Abnormal Metallic Knock Noise from Front of Vehicle

Service Category Drivetrain

Section Hybrid Transmission/Transaxle

YEAR(S)	MODEL(S)	ADDITIONAL INFORMATION
2004 – 2008	Prius	Plant Code(s): 3, 7 WMI(s): JTD

Figure 3.

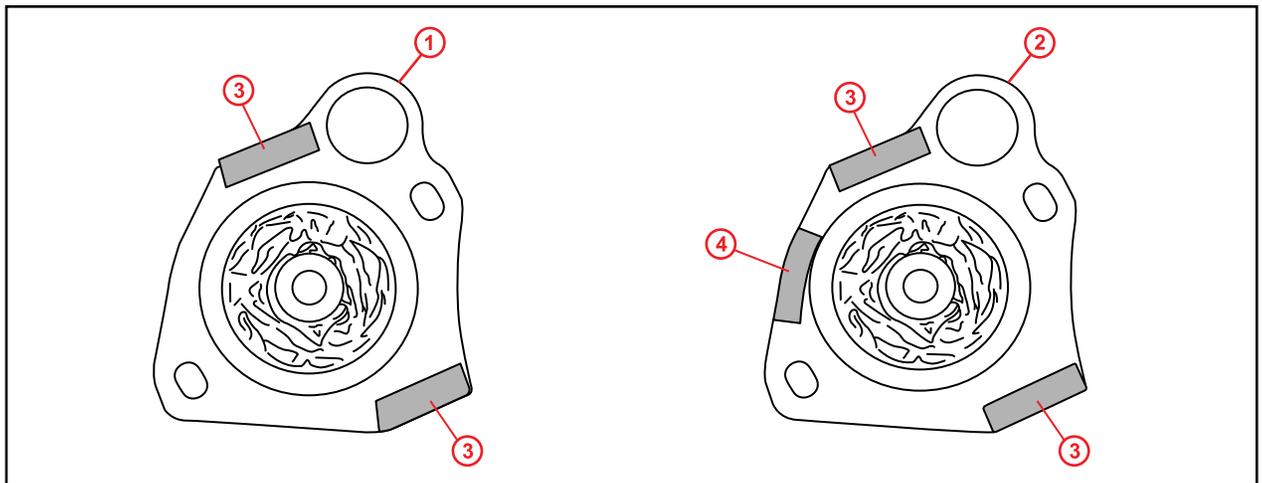
- C. Replace the engine mounting insulator LH with the NEW part (P/N 12372-21111).

1	Old Part (Before Countermeasure)
2	NEW Part (After Countermeasure)

3	EPT Sealer (10 x 35 mm [0.39 x 1.38 in.])
4	Added EPT Sealer (10 x 35 mm [0.39 x 1.38 in.])

- D. Tighten the 2 nuts.
Torque: 64 N*m (640 kgf*cm, 47 ft*lbf)
- E. Attach the engine mounting insulator sub-assembly LH on the vehicle.
Torque: 80 N*m (800 kgf*cm, 59 ft*lbf)
